GMP #79

Subject: Revisions to Experimental Protocol for Puraflo™
Peat Filter Treatment System
Onsite - Product Approval - Puraflo™

GMP #79

Conditions of Approval
Puraflo™ Experimental Protocol

Figure 1

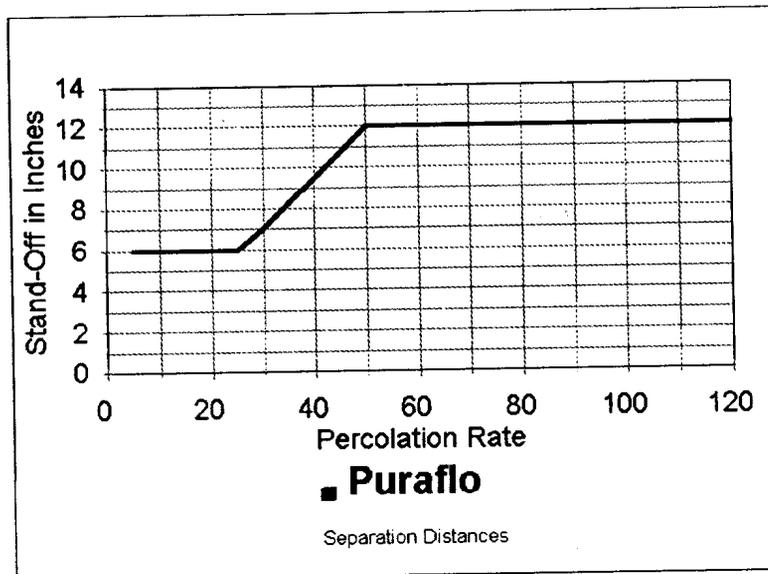
1. Any site that does not comply with the minimum stand-off to rock and/or water table requirements contained in the Sewage Handling and Disposal Regulations but does comply with the requirements of Figure 1. **Note:** In accordance with a variance issued on 03/12/96, these 100 systems require an

The stand-off distances to rock and water table for conventional septic systems are proposed for revision. These revisions may affect the stand-off distance for this system. If the proposed revisions are adopted as drafted, the stand-off distance for the Puraflo™ system will be revised to 12 inches in all soil types.
